E8358A-03

S E R V I C E N O T E

E8358A PNA Microwave Network Analyzers

Figure 1: A3 Front Panel Interface Board Assy without the Bracket

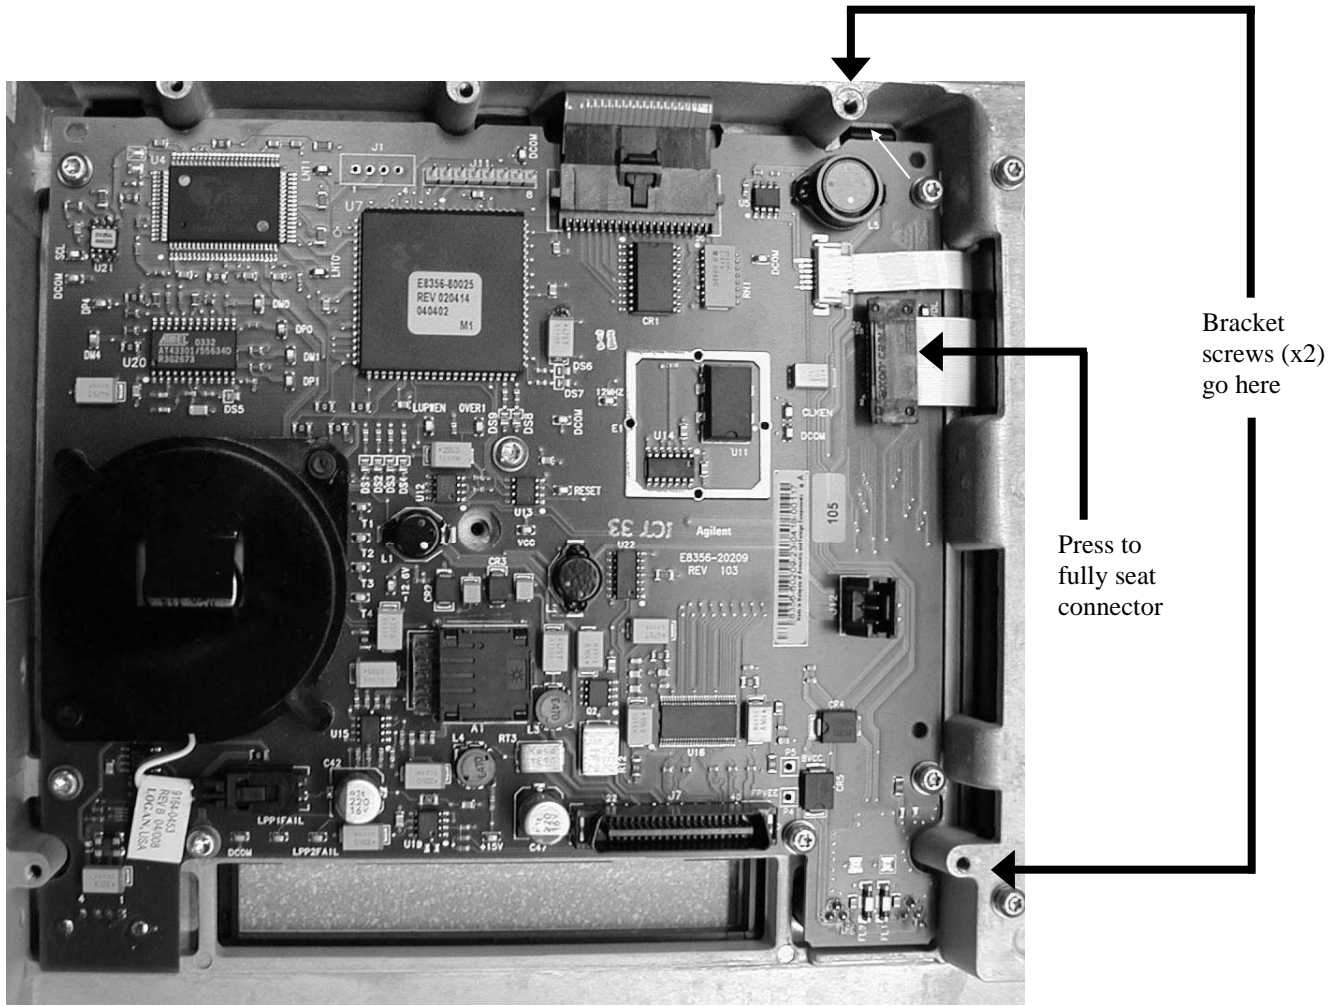
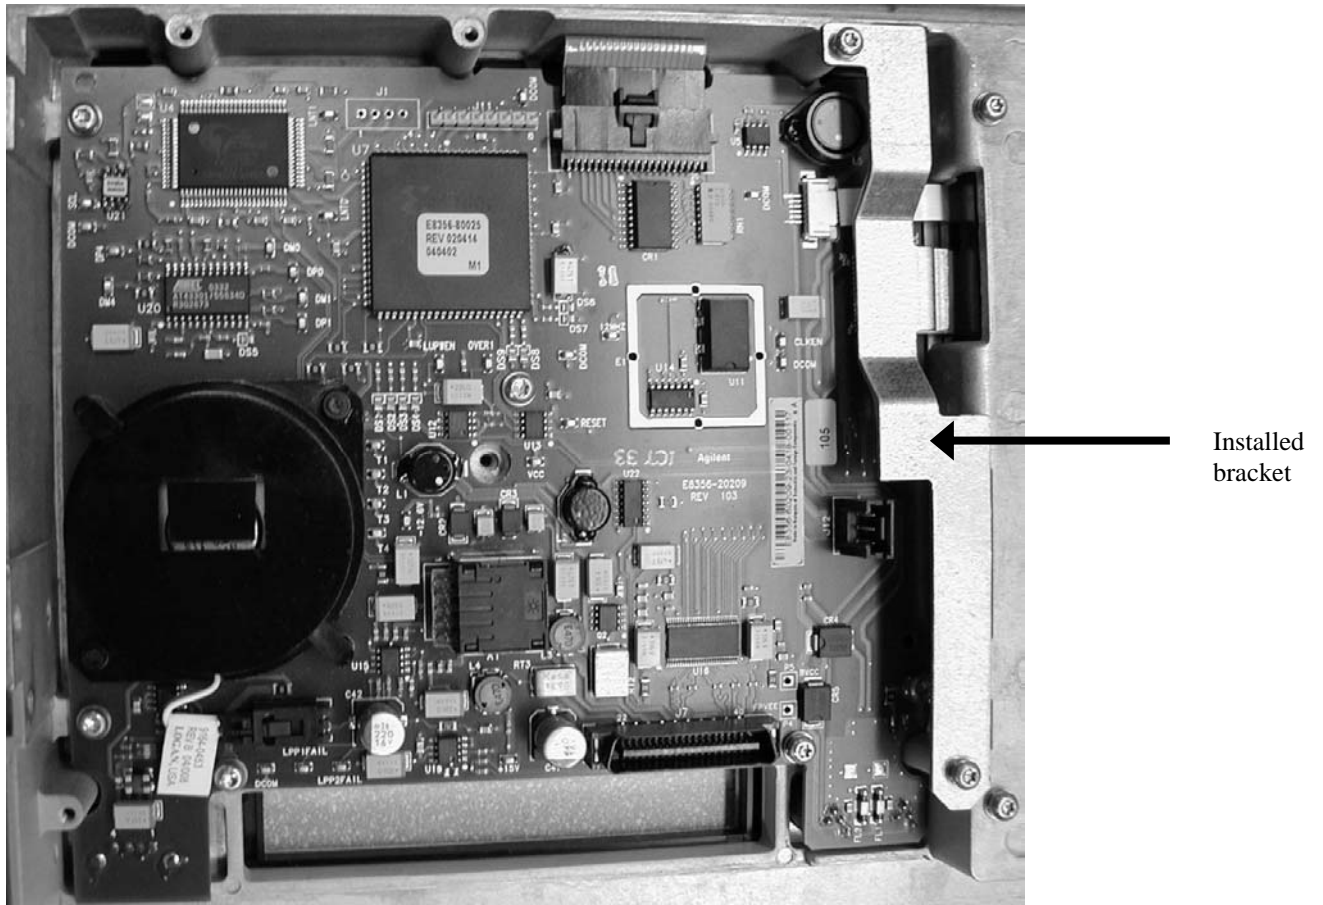
A connector of the ribbon cable (Agilent part number 8120-8409) that joins the front panel display to the front panel interface board can loosen, causing a display failure, unless a new bracket is installed. Because the failure rate has been very low, it is recommended that the bracket be installed only when there is an additional reason to remove the PNA front panel.

1. Refer to Figure 1 in this document:
 - Press down firmly on the ribbon cable's black connector.
 - Locate the two tapped holes for the bracket screws.
2. As shown in Figure 2 in this document, position the bracket so that its holes line-up with the two holes you located in the previous step.
3. Hand-start the two screws, and then torque both to 9 in-lbs.
4. Reinstall the PNA Front Panel by following the Service Guide instructions in the "Replacement Procedure." This is located on the same page as the "Removal Procedure" used previously in step 7.
